## Report to Planning and Environment Committee

**Subject:** Royal Premier Homes  
307 Fanshawe Park Road East

**Public Participation Meeting on: September 23, 2019**

Figure 3 Proposed Landscape Plan

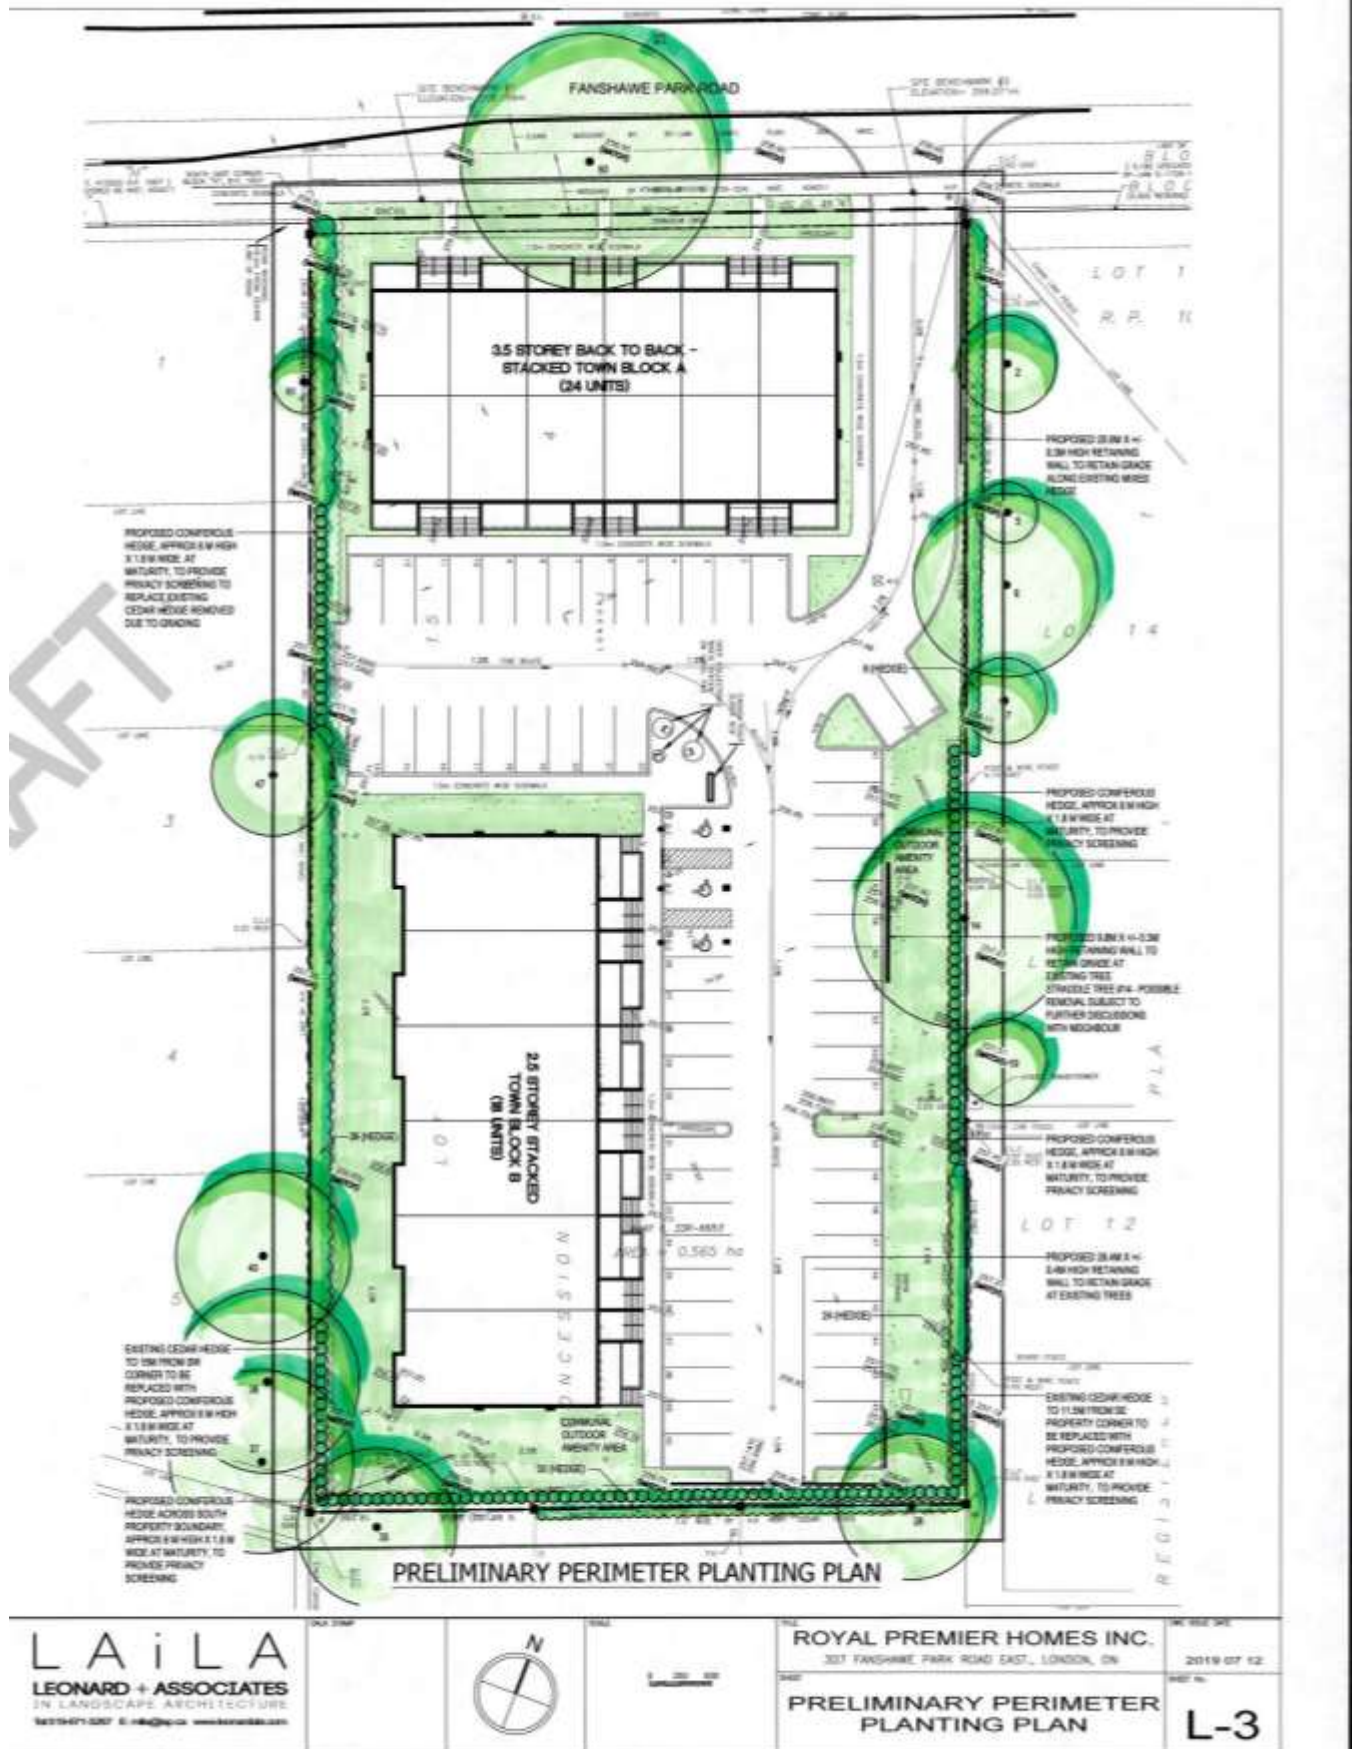
The applicant submitted a Tree Protection Plan dated November 2018 and prepared by Leonard + Associates Landscape Architecture. The November 2018 report stated that all trees on site were to be removed. The only trees to be retained were boundary cedar trees located on the east and south lot lines. The applicant, following the June 2, 2019 PEC meeting submitted an updated tree protection plan (see figure 3) dated June 11, 2019. On this plan the applicant proposes to retain an additional six (6) trees within the site as well as retaining most of the existing boundary hedges or replacing those boundary hedges that are proposed to be move removed due to grading or other site development

The Revised Tree Plan looks simpler, but reveals that even fewer trees will be spared (14 instead of 20). The majority of trees preserved in this plan are on neighbors' property. The hedge also is less well preserved. Where there are little green circle indicators, these are replacement or new hedging that might be 3 ft high, or six feet... who knows? Written clarification and promises on this point would make a world of difference. There are those among us who could care less if the bottom of the hedge was scruffy as long as the upper 20-30 feet buffered the noise and visibility of the proposed buildings. Others might be happy to reach a compromise. We cannot see that 20-30 hedge on the NW corner will survive the swale proposed, but we are not arborists. We will require written assurances that the proposed tree protection zone will suffice to keep the coniferous (cedar) hedge alive. Excepting the hedge (with deficits indicated above), there is no proposed deciduous tree replacement plan, so the impact of the removal of almost all trees on the property is still impossible to understand or to assess.

Through the site plan process, a development agreement will be entered into which includes the requirement for all protection measures to retain the trees as identified in the June 1, 2019 updated plan.

Figure 4 Cross Section of Stacked Townhouses

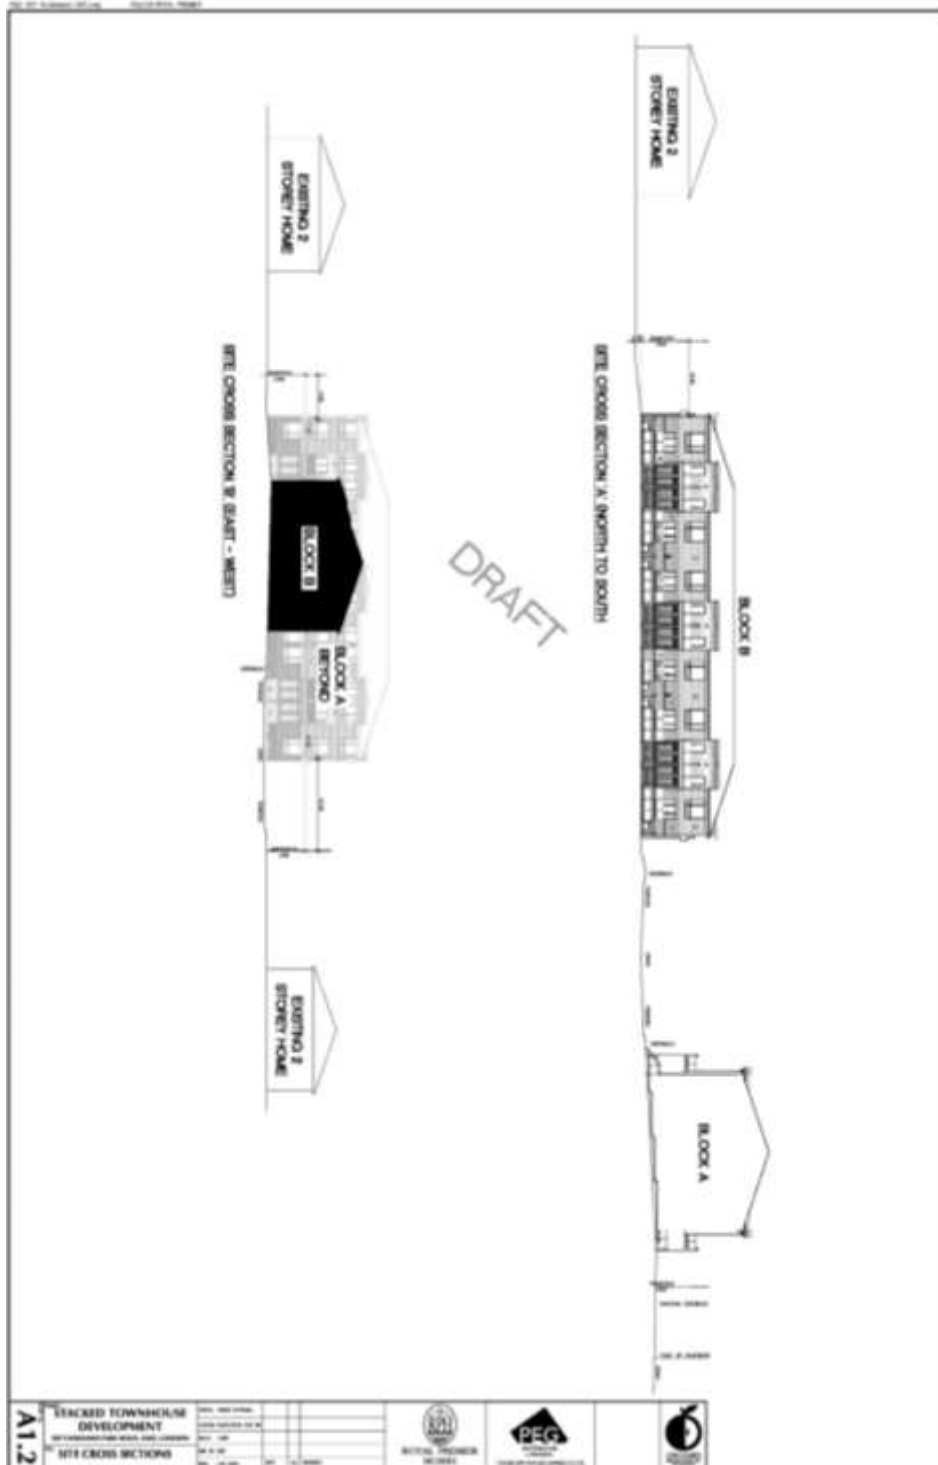
During the public consultation process leading up to the previous meeting of the Planning and Advisory Committee where this application was presented, it was believed by members of the public that this site would require significant fill to raise the grading of the site to disperse stormwater flows to sewers located at Fanshawe Park Road E and the rear of the subject site. This scenario created concern that the proposed townhouse buildings would be situated significantly higher than the adjacent single detached dwellings causing issues with overlook into rear yards.

However, as part of the referral back to Staff, the applicant prepared new elevations and cross sections that depict the opposite – whereby the site will be inversely graded such that the southerly proposed townhouse building located interior to the site will sit lower than the northerly building fronting Fanshawe Park Road E resulting in a similar grade to that of the neighbouring properties (see figure 4 above).

Figure 8 Site Grading Plan

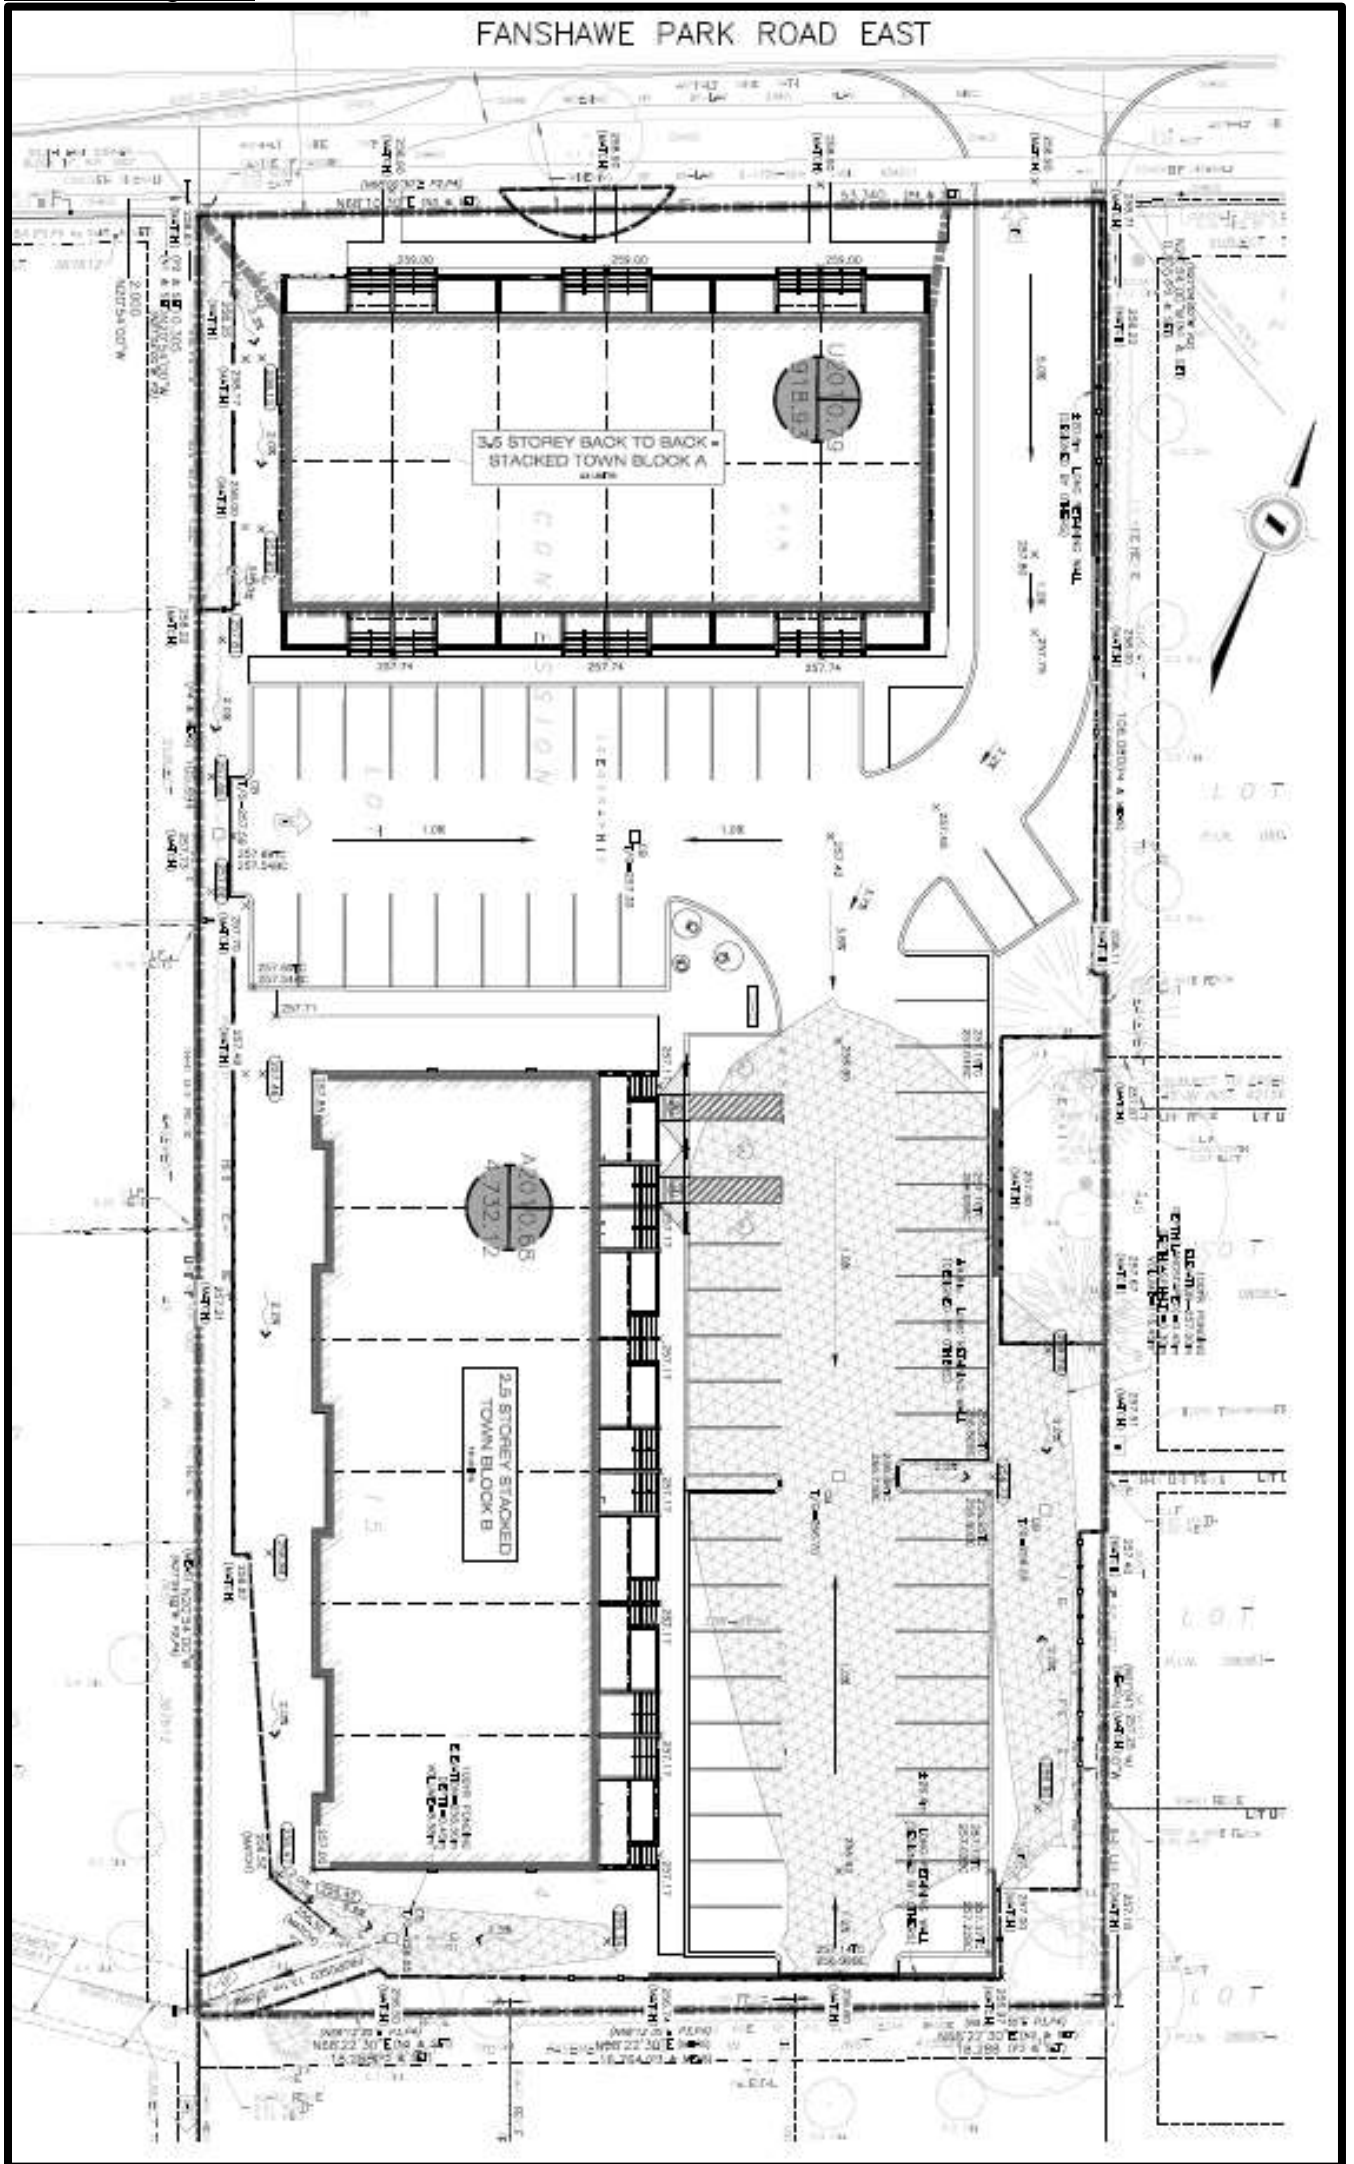
The grading has been clarified and substantially revised. The good news is that instead of the site being convex and raised with a high point situated in the middle of the Northern parking lot, it is now partly concave with the larger parking lot defining a bit of a site-localized depression to collect water during storms. As we predicted, the swales are now clearly indicated to circumscribe much of the lot. The size of the proposed parking lots necessitates pushing the storm/snowmelt management system - the swales - to the very periphery. This peripheral swaling in turn drives the necessity to remove even more buffering trees.

The design of the parking area will include a bowl shape that is intended to act as an overflow water retention feature should a significant storm event overwhelm the stormwater sewers and additional flows cannot be accepted. In this case, the stormwater will pool in the parking area and drain into the catch basin when normal conditions return (see hatched area in Figure 8 below).
